Technical Bulletin

Bulletin No.: PRO-01-22 Effective Date: 11/17/81 Page: 1 of 3

Subject: **New Cylinder Head Design Tu-Flo 700 Compressor**

I. NEW STYLE CYLINDER HEAD

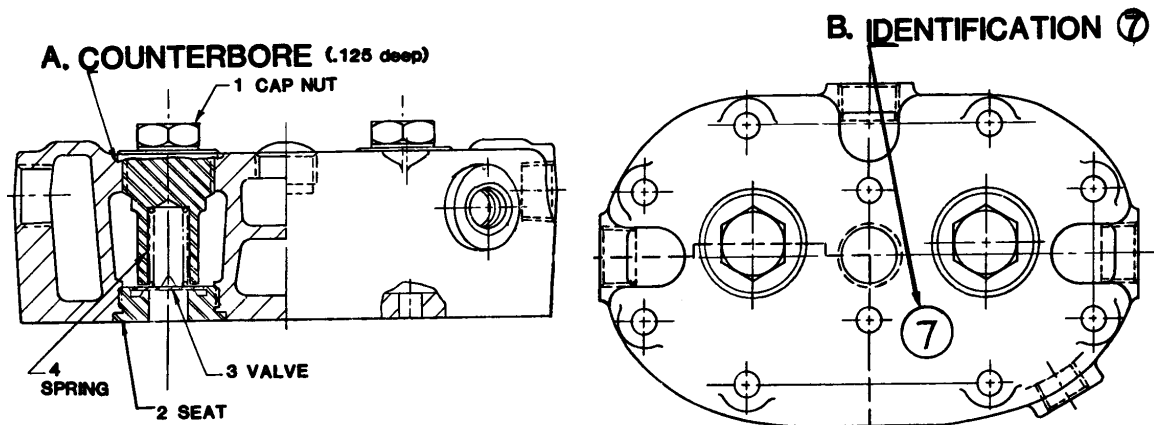
Approximately December 1, 1981 changes will be made in the discharge valve area of all new Tu-Flo 700 Cylinder Heads, which will result in improved compressor performance. Remanufactured Tu-Flo 700 Compressors will be changed on a running basis in the near future.

The new style cylinder head is identified by:

- A. A counterbore (approx. 3/16" deep) of the cylinder head where the cap nut is installed.
- B. A figure "7" with a circle around the figure, stamped or cast into the head surface.

KEY NO.	PC.NO.	DESCRIPTION
1	236215	Cap nut
2	294751 or 237291	Seat
*3	230935	Valve
*4	292375	Spring

*Items 3 and 4 are included in T/F 700 Maintenance Kit Pc. No. 229417 (for T/F 700 compressors new style cylinder head only.)

II. OLD STYLE CYLINDER HEAD

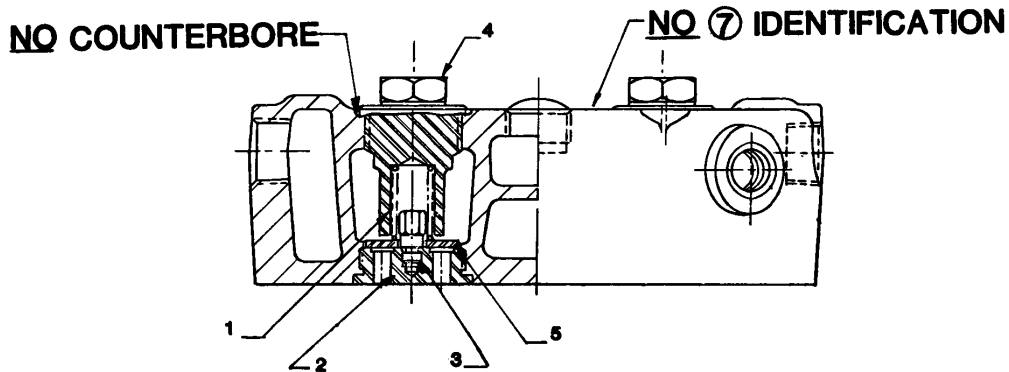
The old style cylinder head can be identified by a shallower 3/32" counterbore and it has no ⑦ identification.

When service replacement of any of the following parts is required, all of the following parts must be removed and should not be reused in the old style cylinder head.

When replacing parts, order Pc. No. 102727 Discharge Valve Kit or Pc. No. 289998 Tu-Flo 700 Maintenance Kit.
